PLANNING COMMITTEE 8th January 2014

THE FOLLOWING ALTERATIONS AND AMENDMENTS HAVE BEEN RECEIVED SINCE THE PLANNING OFFICER'S REPORT WAS PRESENTED TO MEMBERS

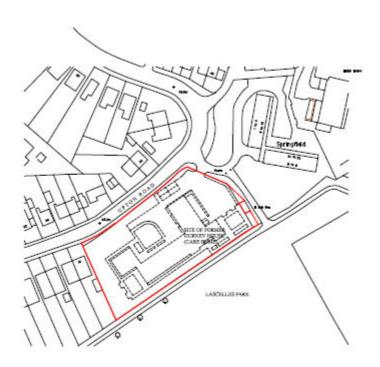
The application site boundary on the agenda does not reflect the change to the north boundary recently made by the applicant and referred to in the report. The revised boundary is below.
